**ELECTRICAL ADDENDUM #E-1
VICKER'S KITCHEN AND DINING FACILITY
CFB BORDEN
MAY 29, 2013**

The following document is hereby made a part of the Contract Documents.

The following revisions and/or additions shall be made to Drawings and/or specifications and the cost shall be included in Tender Price.

SUBJECT | SUJET: ENLARGED ELECTRICAL PLANS

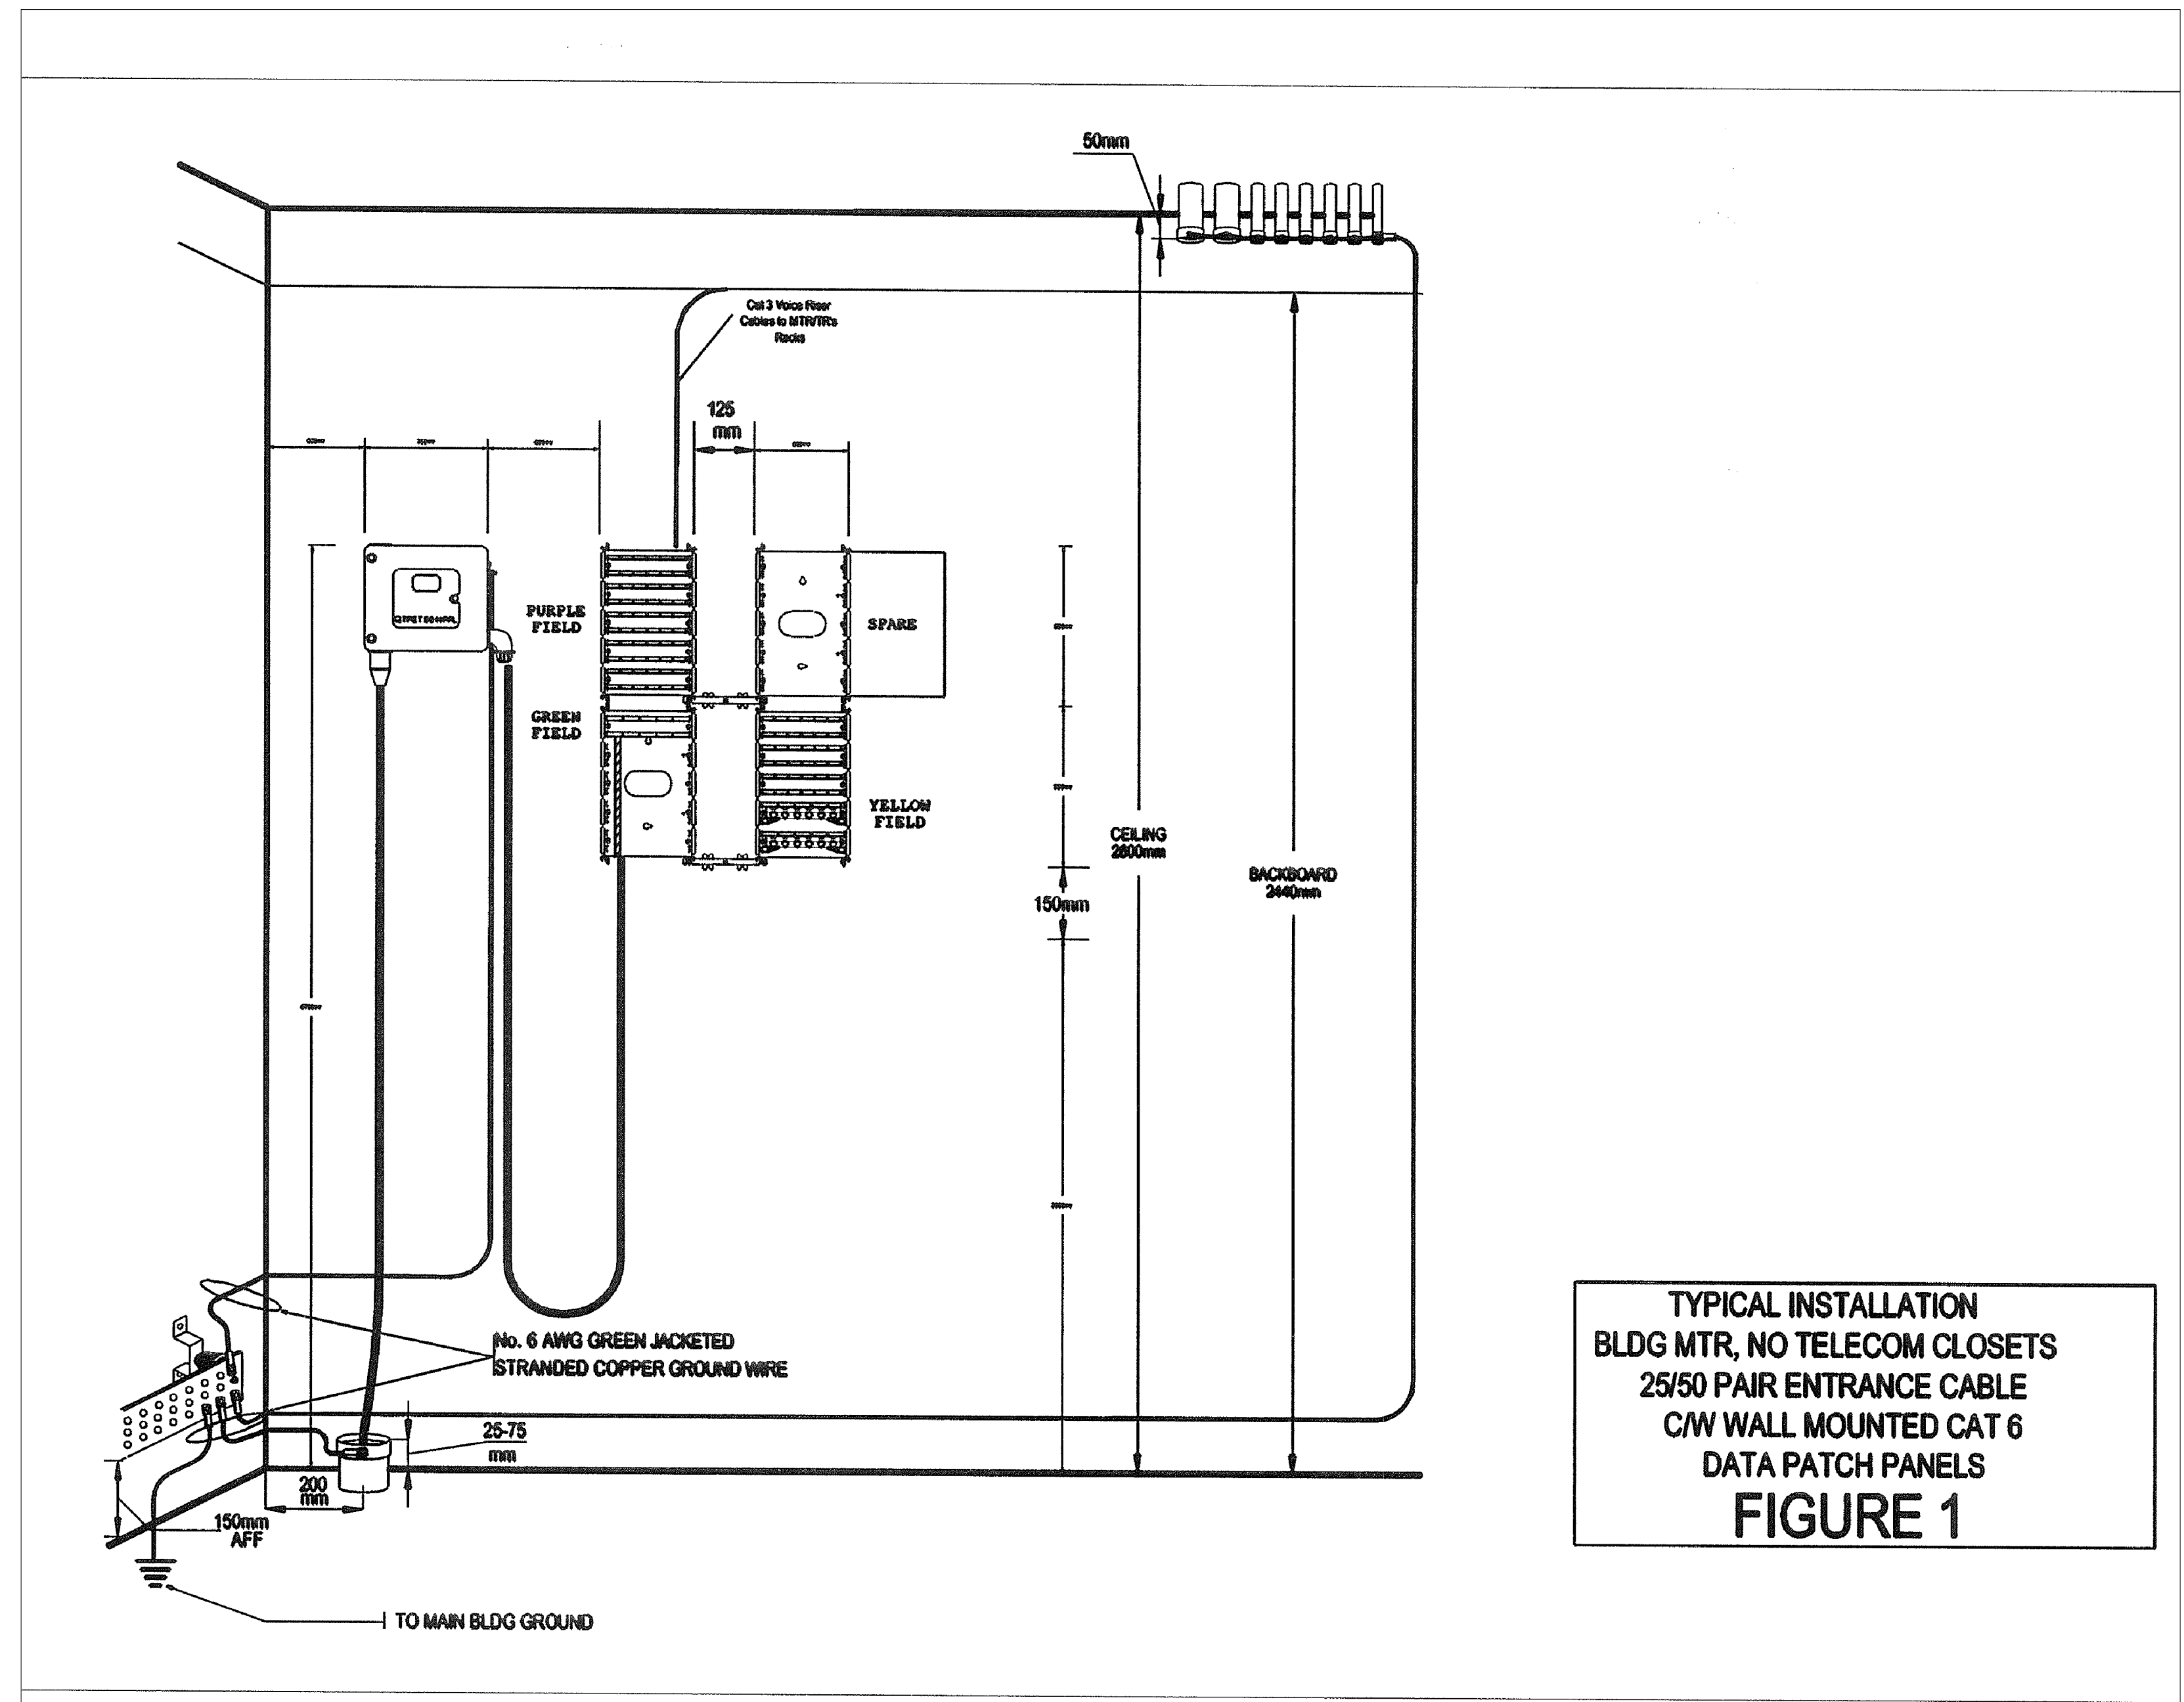
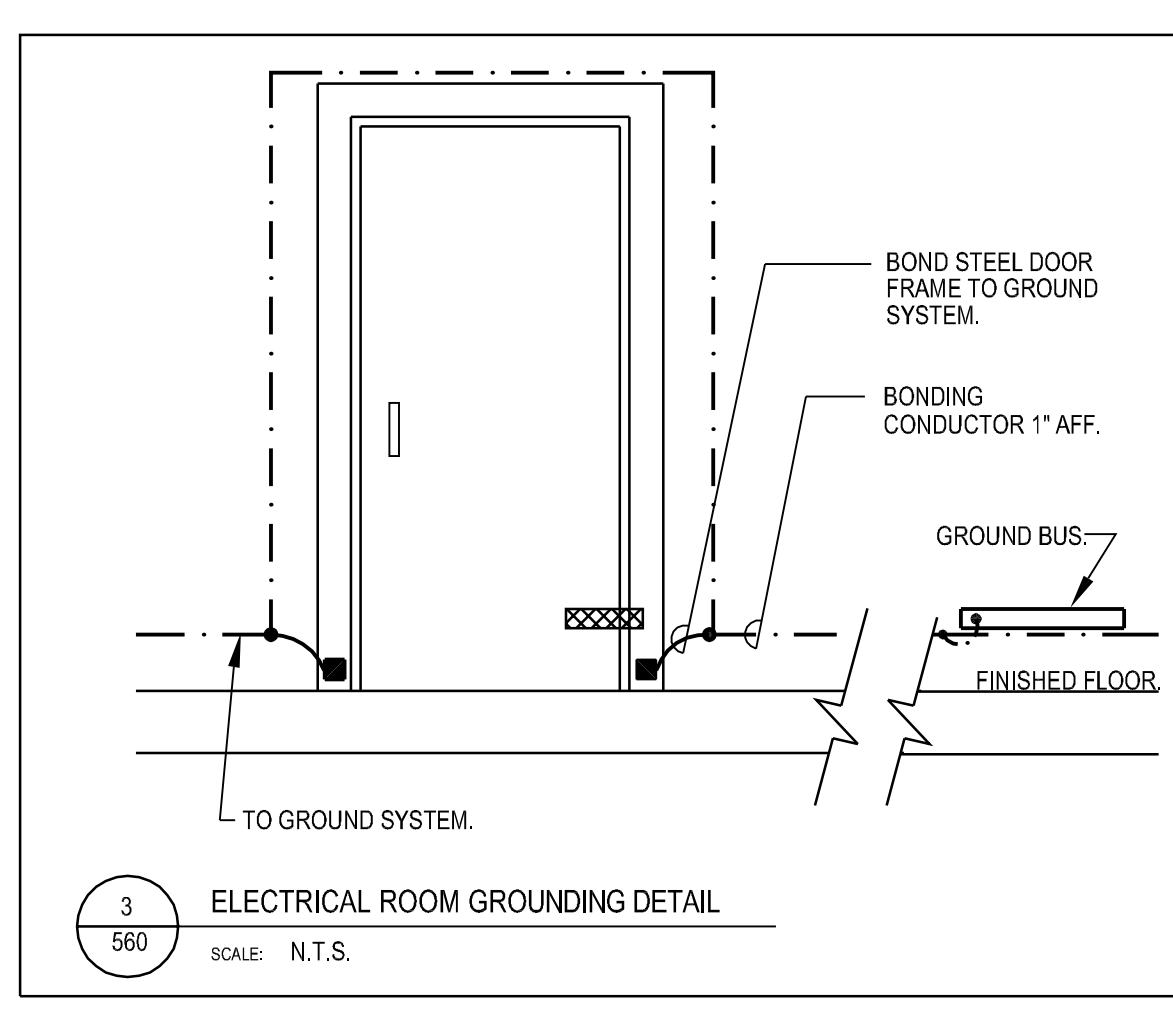
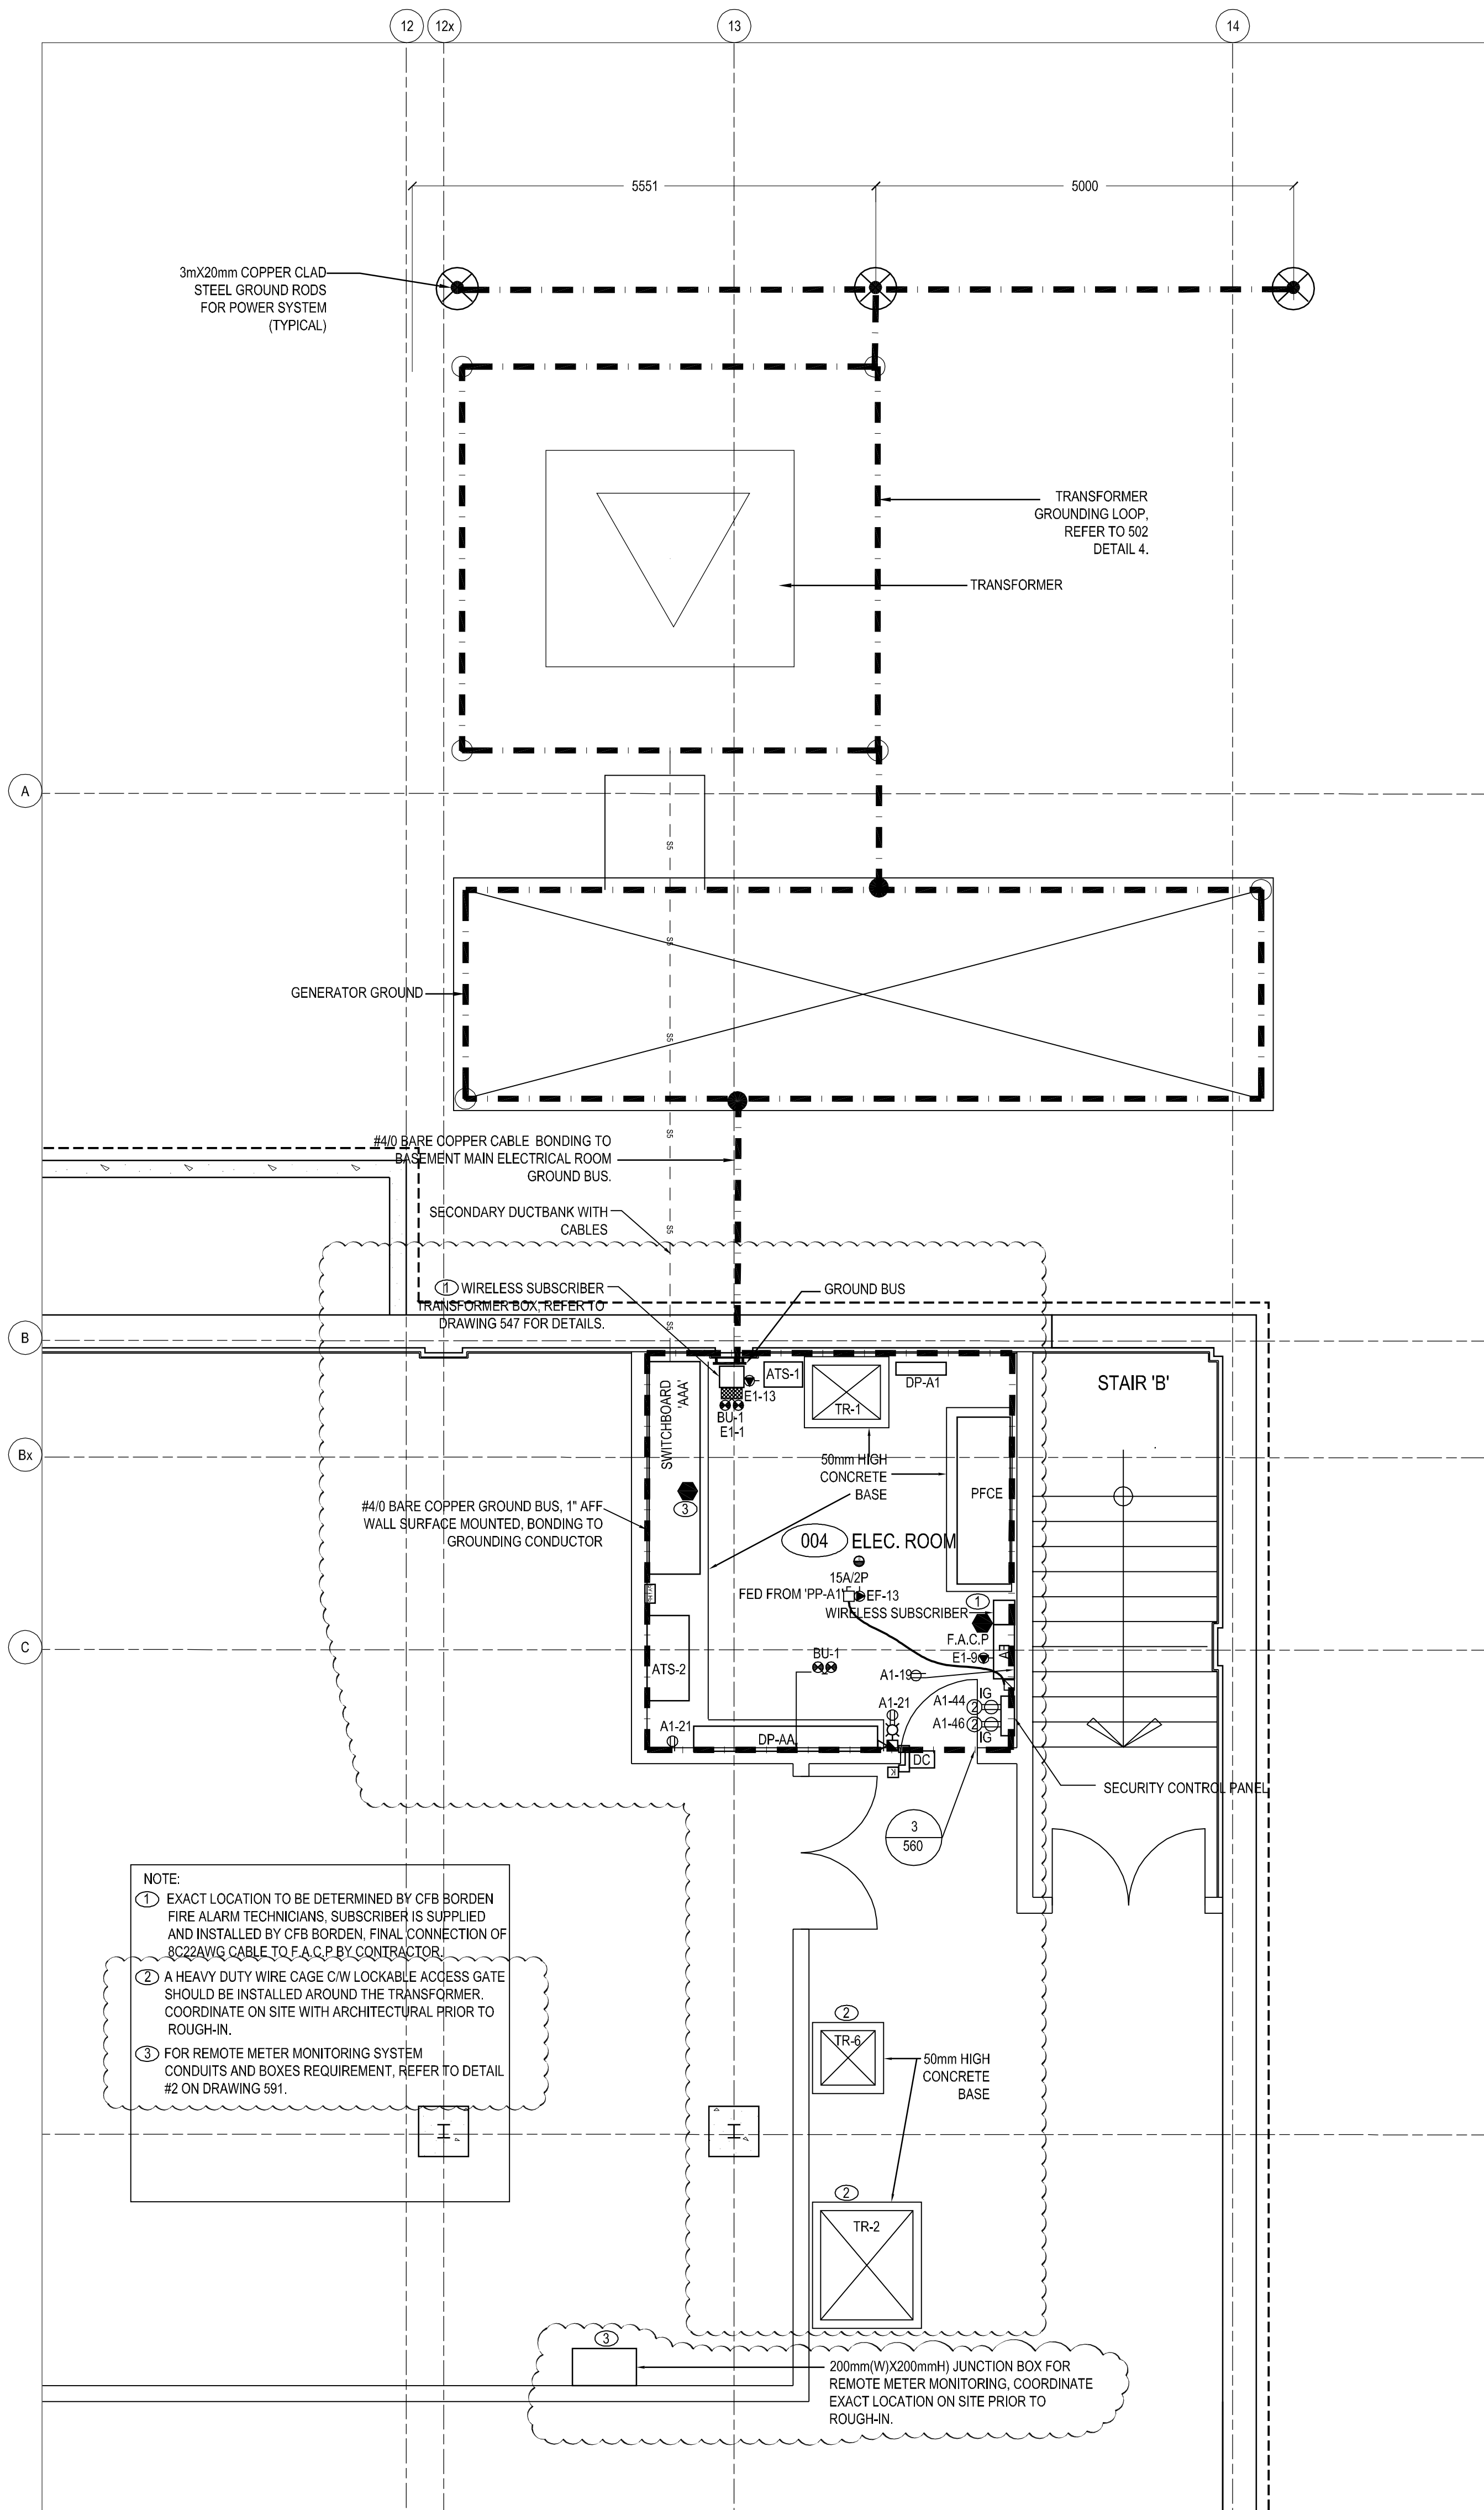
1. Revise Electrical Room 004 layout as per re-issued drawing.
2. Revise Fire alarm "Wireless Transmitter/Transponder" to "Subscriber". Shown fire alarm Subscriber transformer box; Revise power supply for F.A.C.P to 15A/1P, CCT #E1-9.
3. Provide junction box for remote meter monitoring system in Mechanical Room 003.
